Addendum No.: 1

Date Of Addendum: 12 March 2019

CT DAS | Construction Services | Office of Legal Affairs, Policy, and Procurement
Department of Motor Vehicles
Hamden Roof and HVAC
1985 State Street
Hamden, CT
BI – MM-54

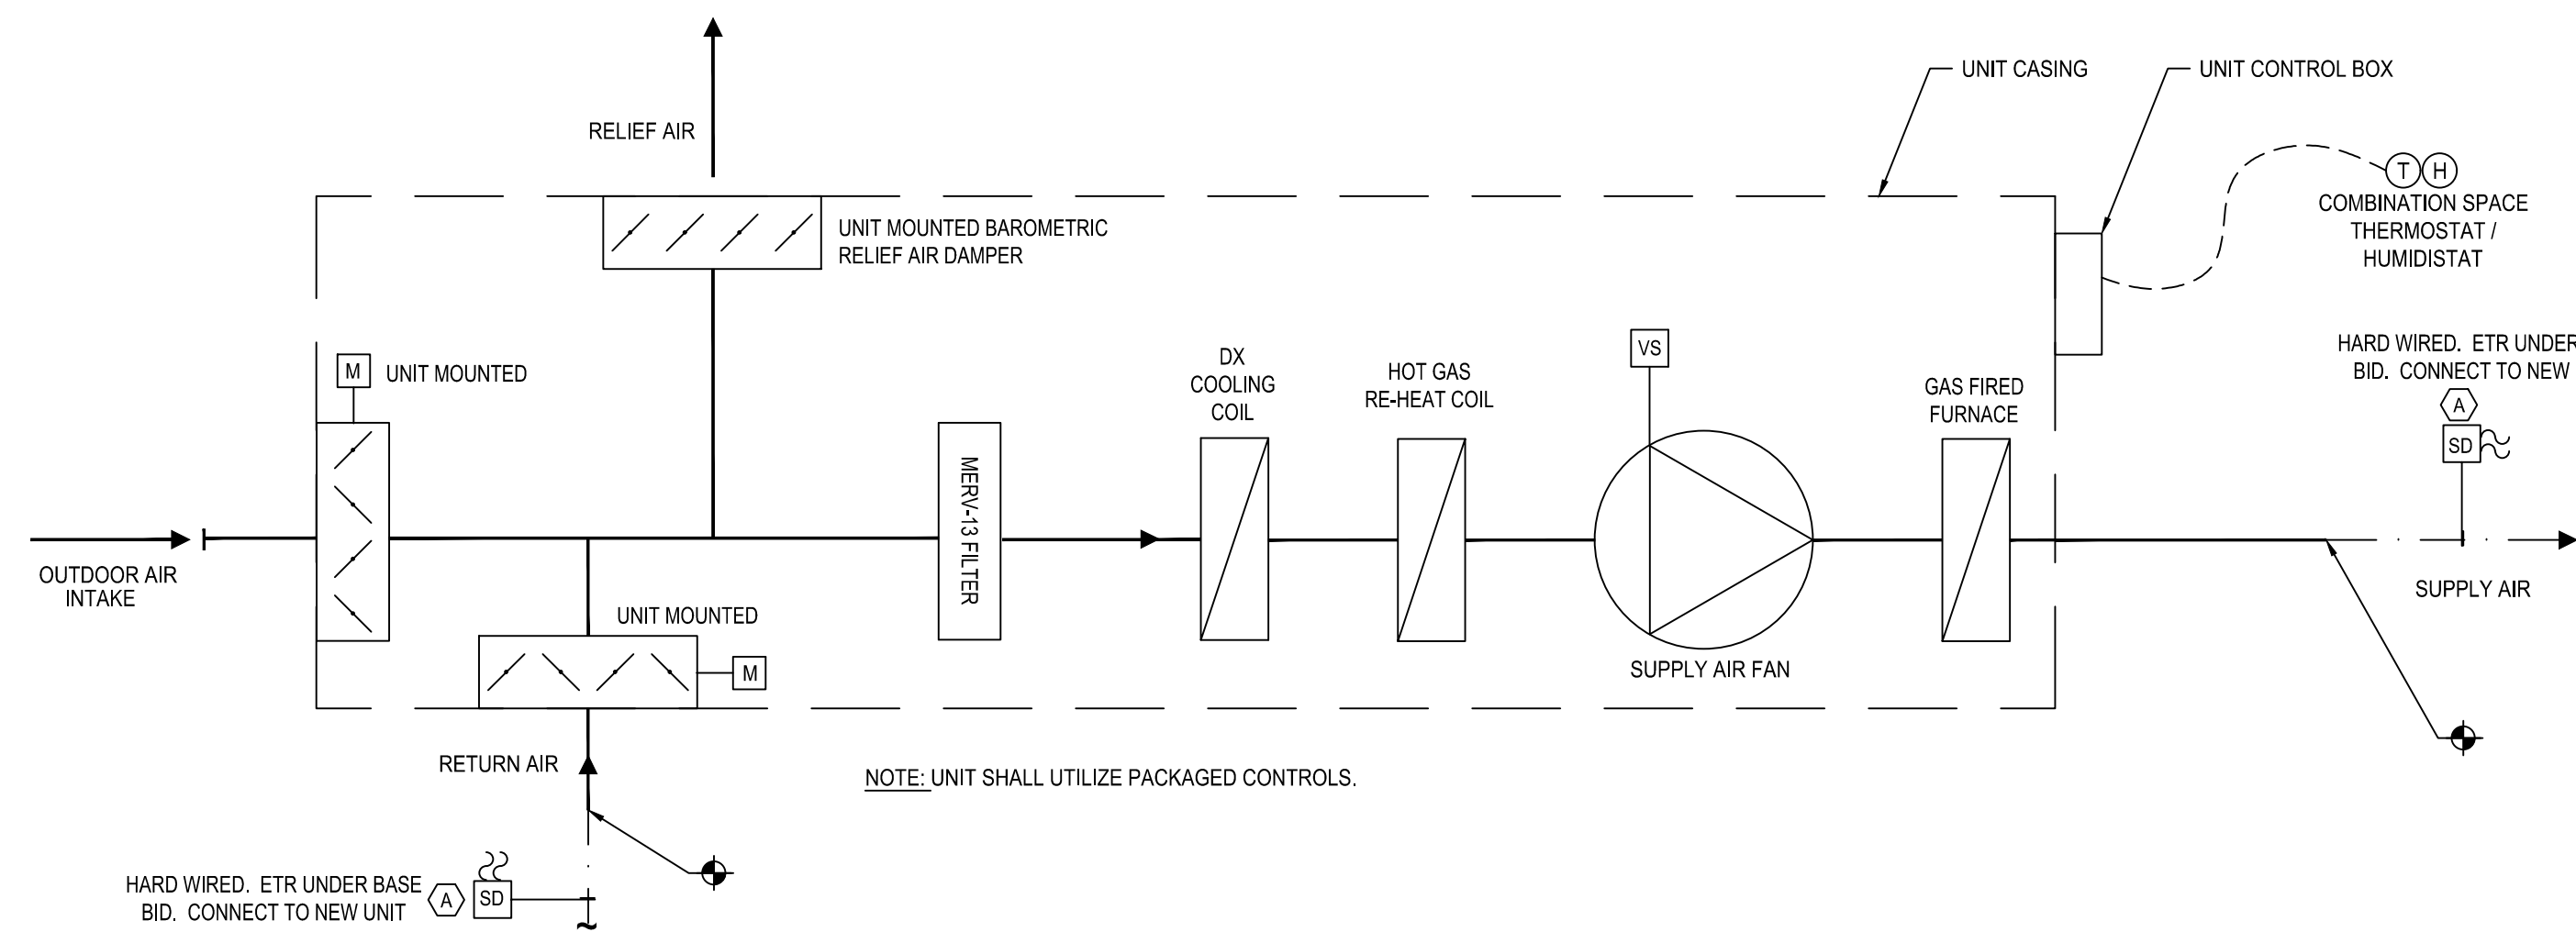
In Drawing M-300 Schedules – Mechanical:

REVISION: Modify no hub unions for above ground storm drain in "HVAC Piping/Tubing Material, Joints & Fittings" schedule and trap size in "Plumbing Drain" Schedule.

SUBSTITUTE: Drawing M-300, dated 03/04/19 Addendum 1

1 ROOF MOUNTED DUCTWORK SUPPORT DETAIL

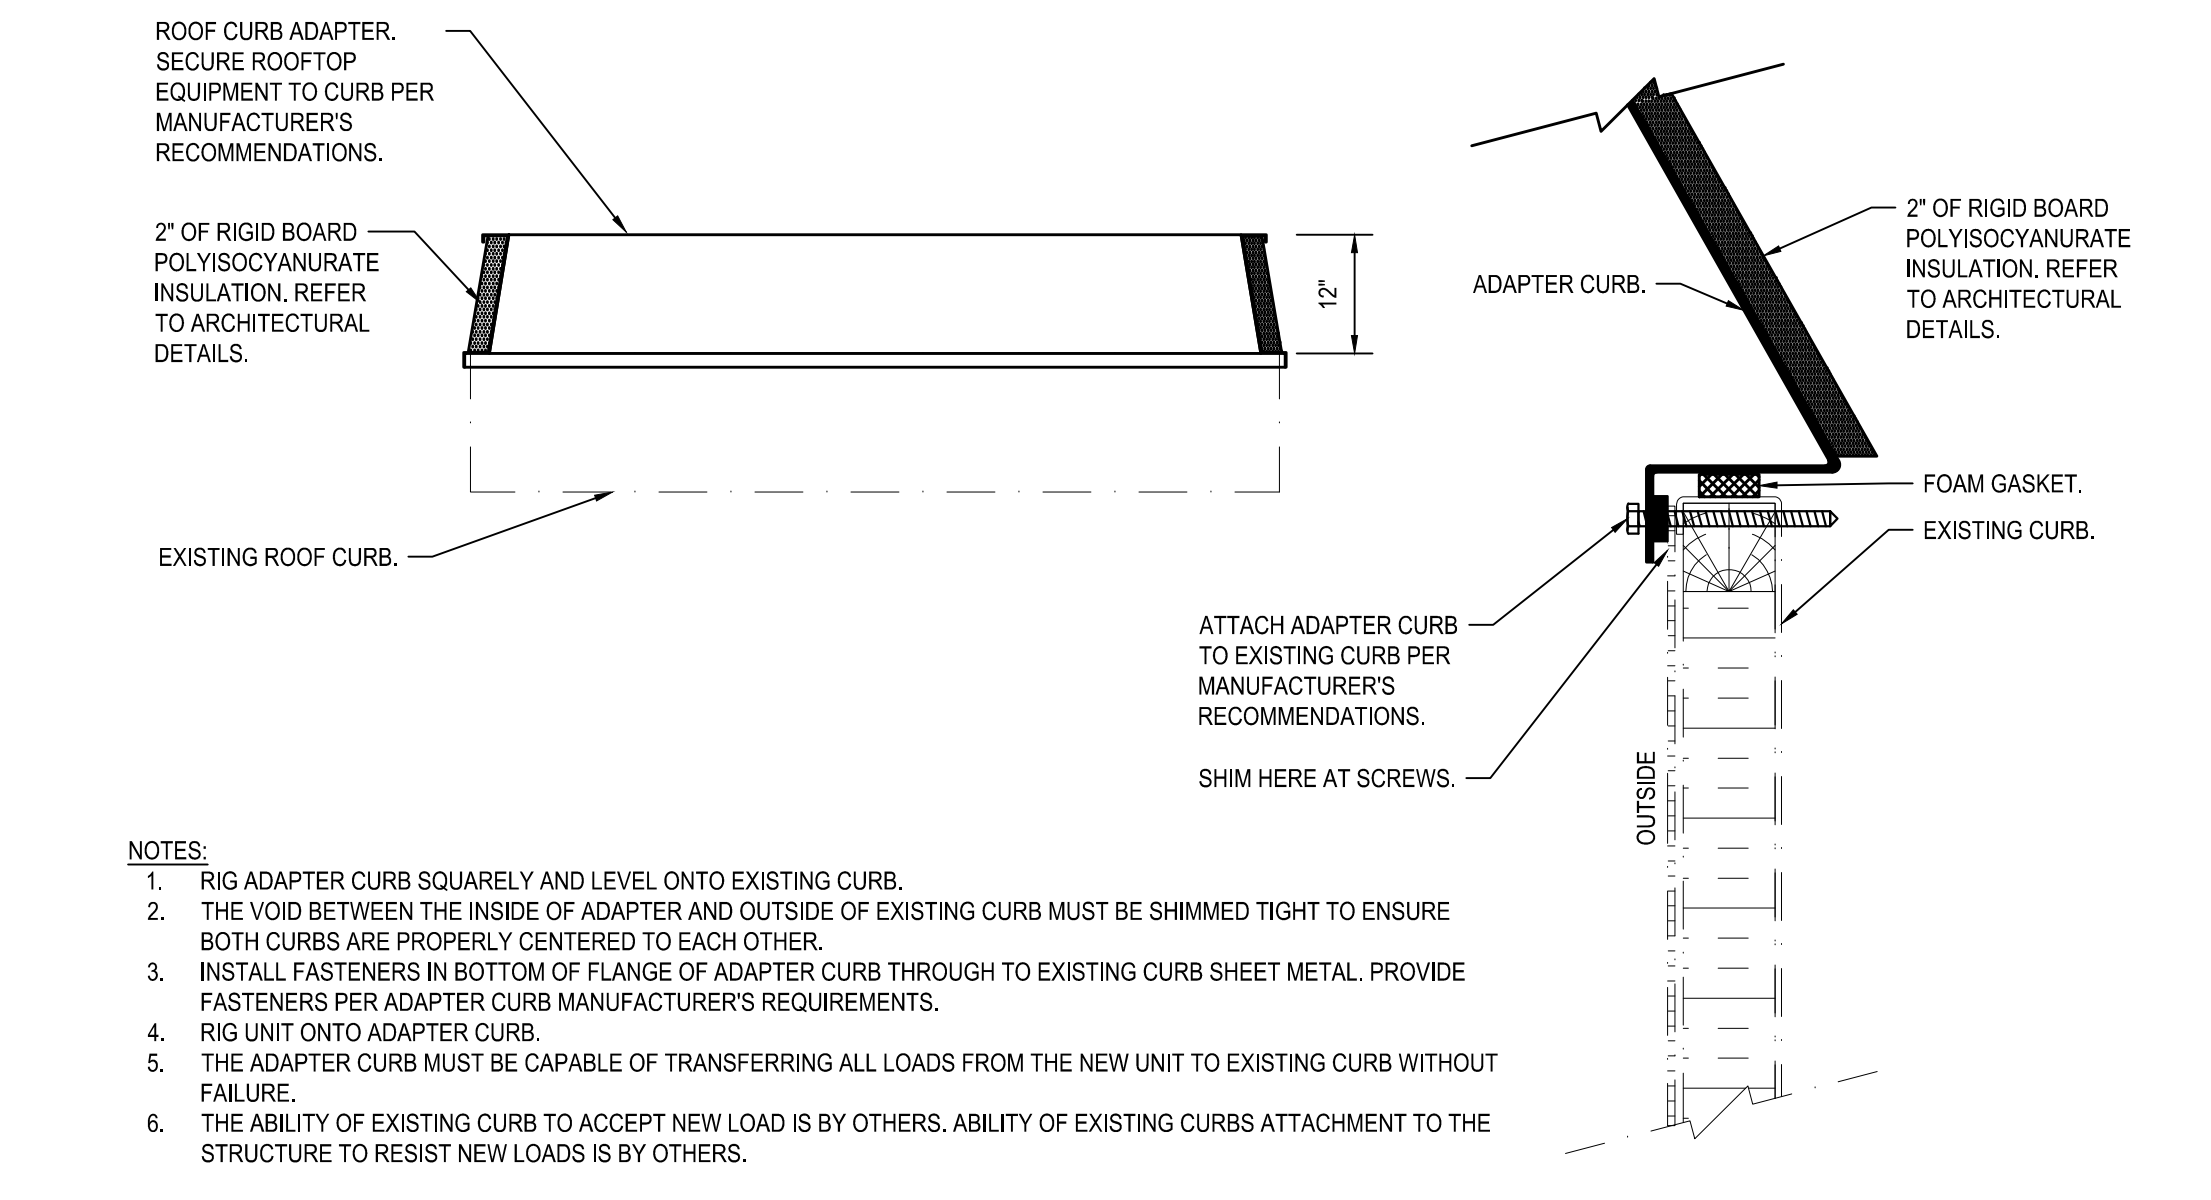
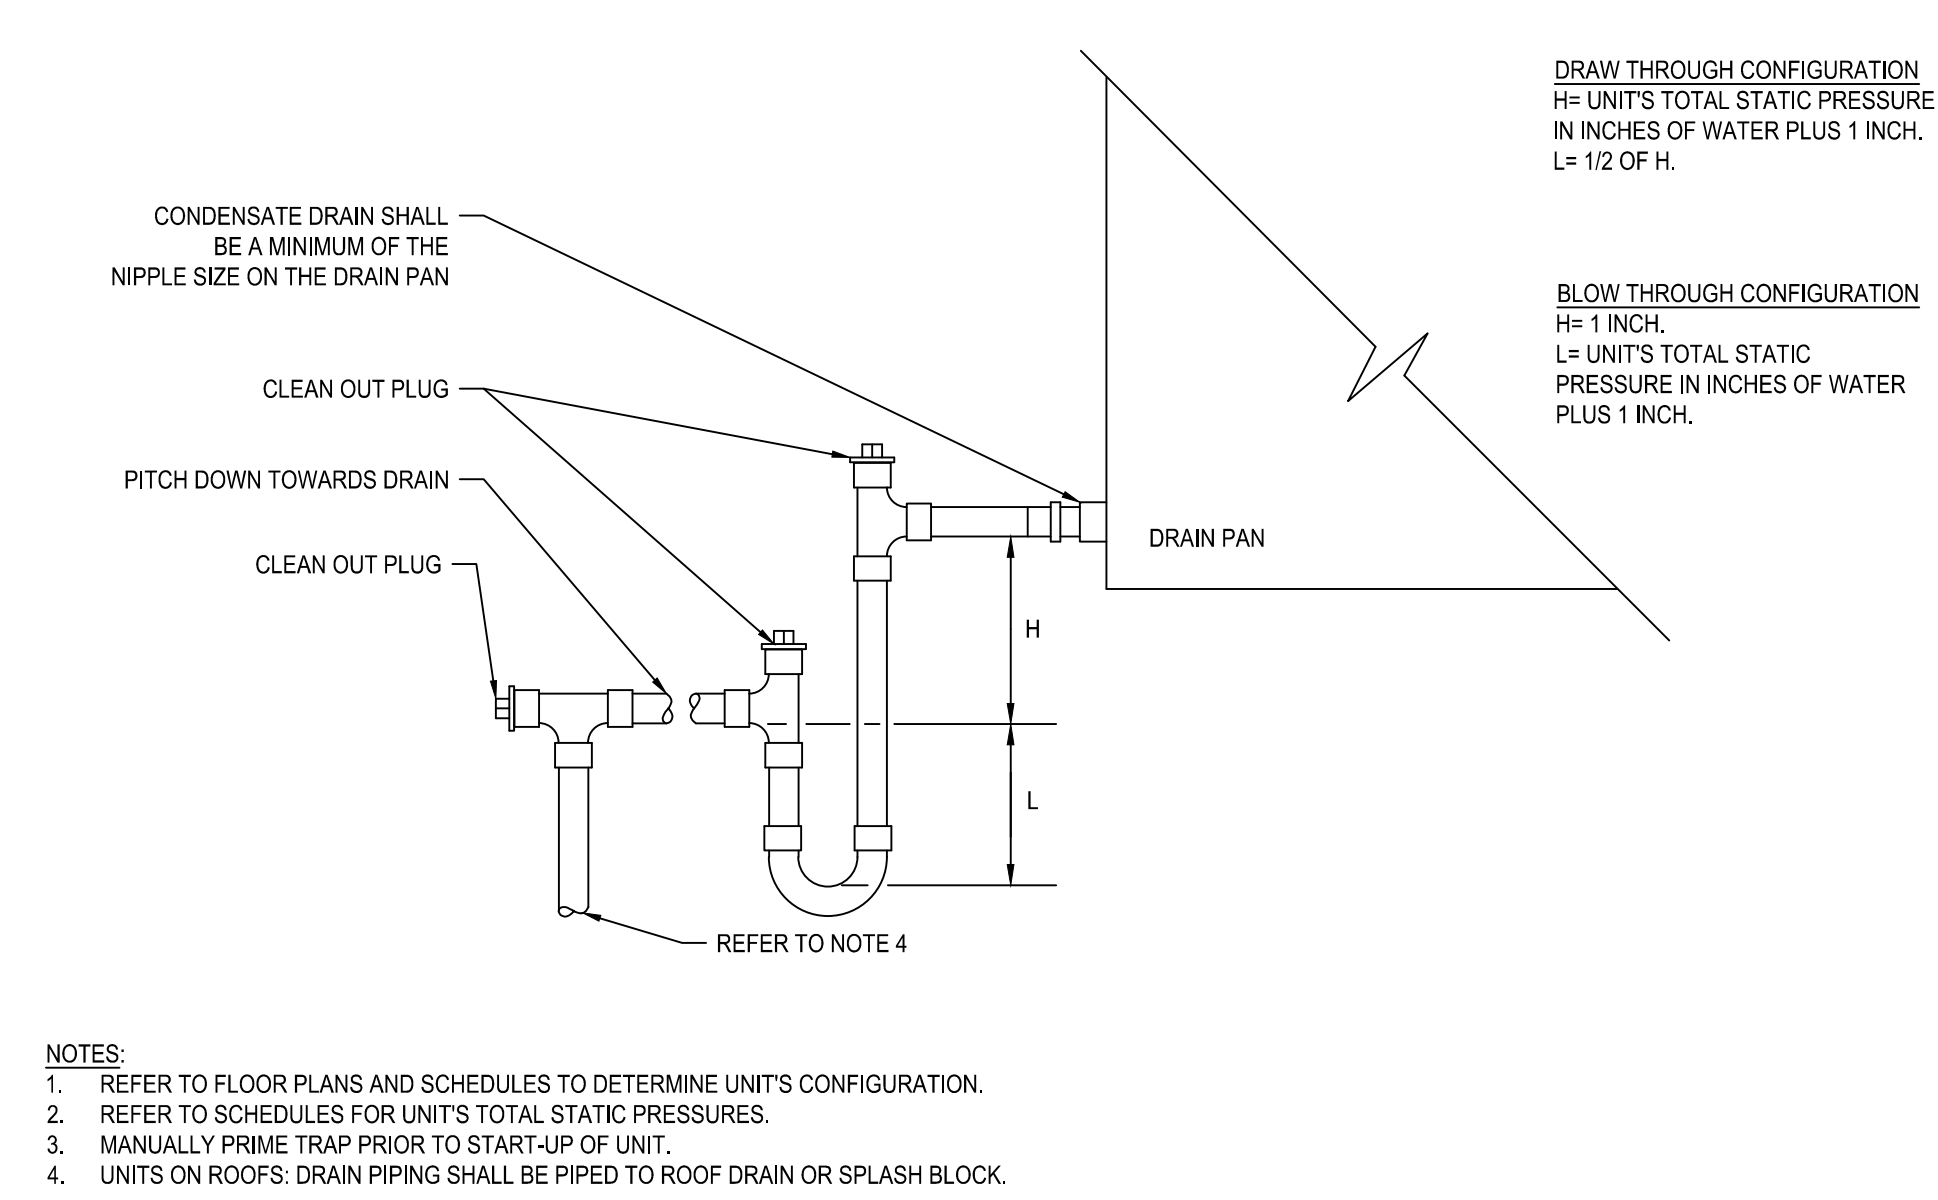
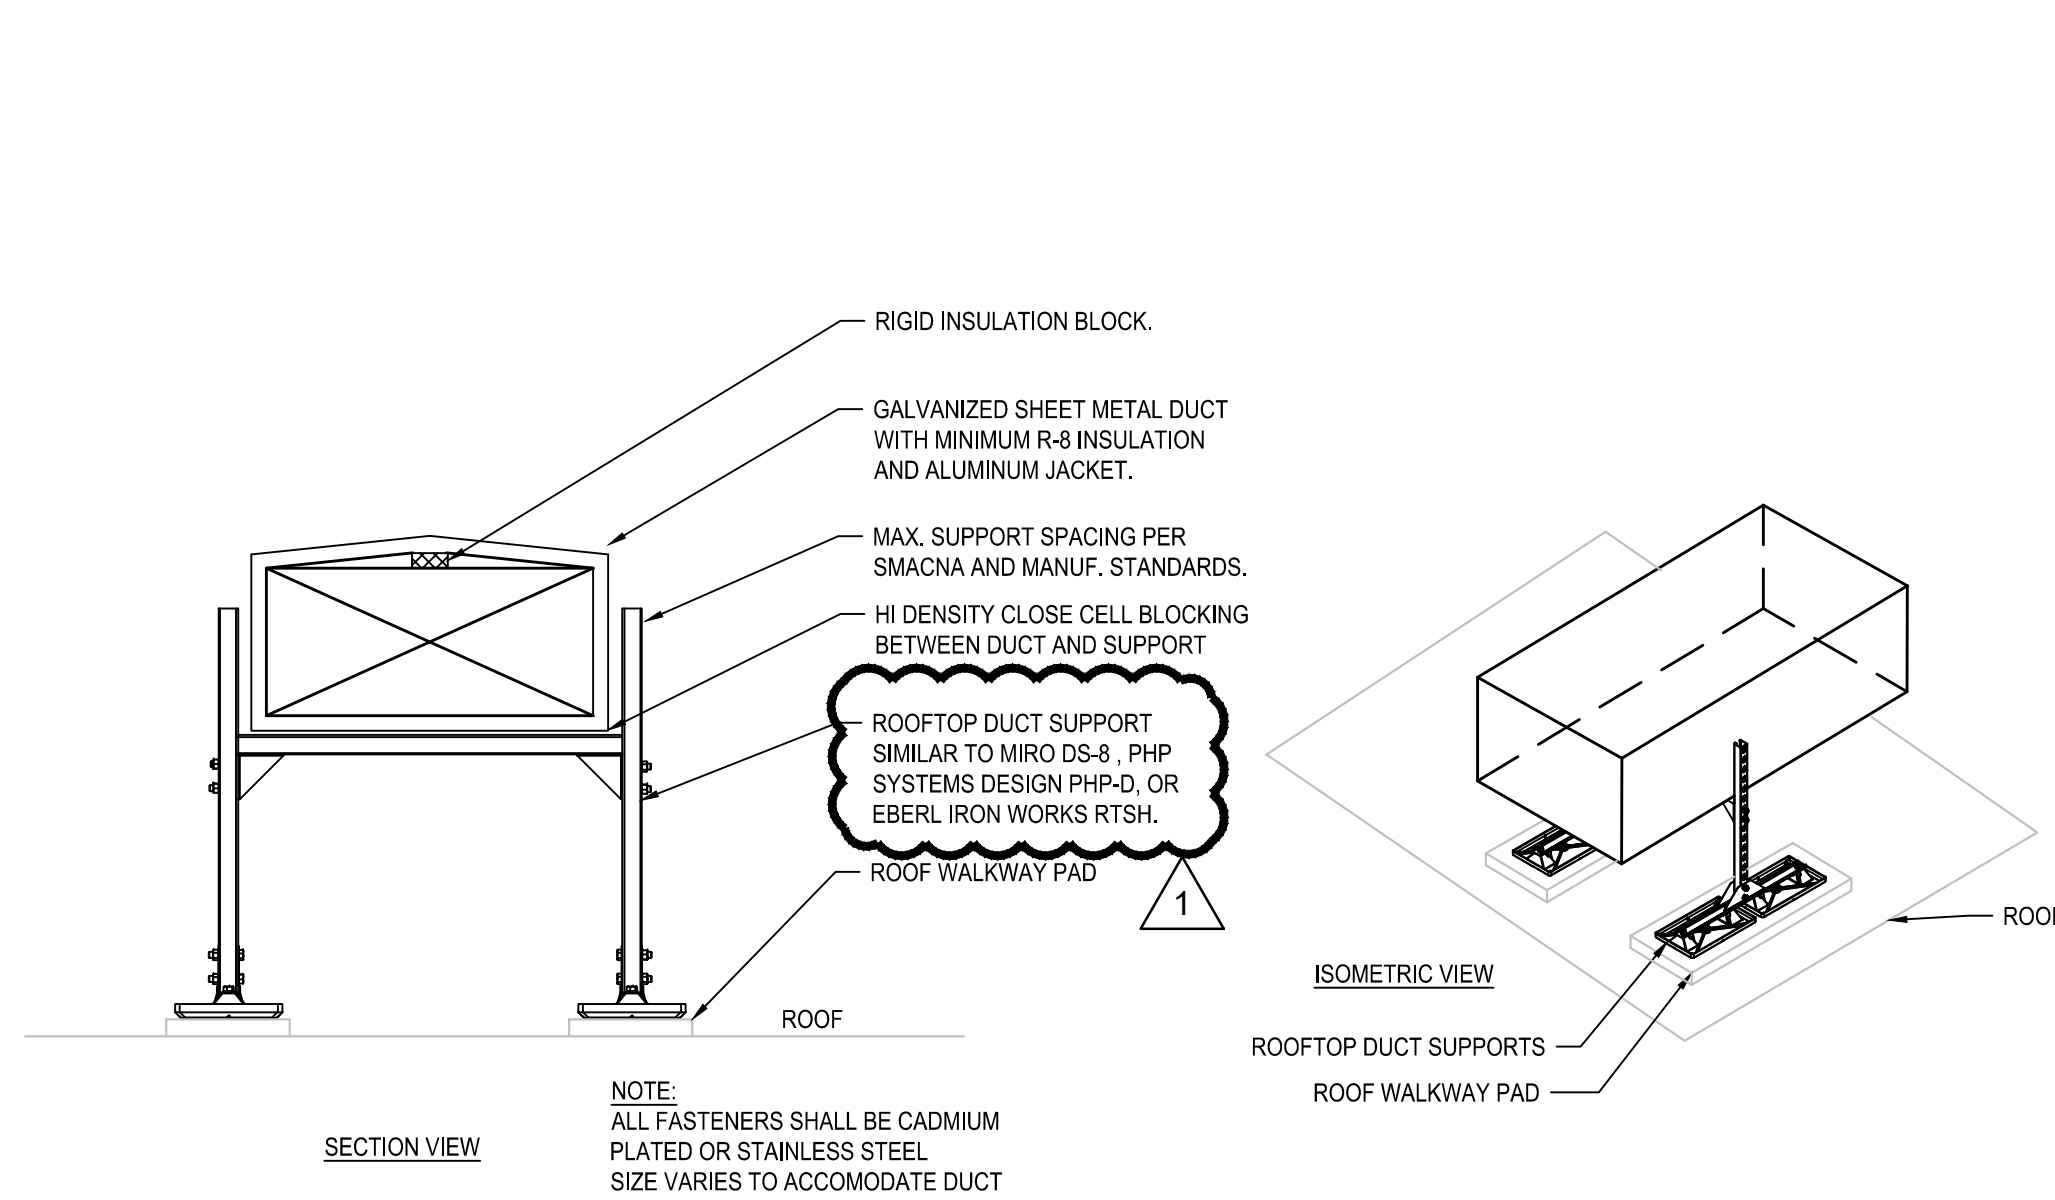
In Drawing M-400 Details – Mechanical:

REVISION: Modify Detail 1/M-400 Modify ductwork support note to include additional manufacture names and model numbers.

SUBSTITUTE: Drawing M-300, dated 03/04/19 Addendum 1
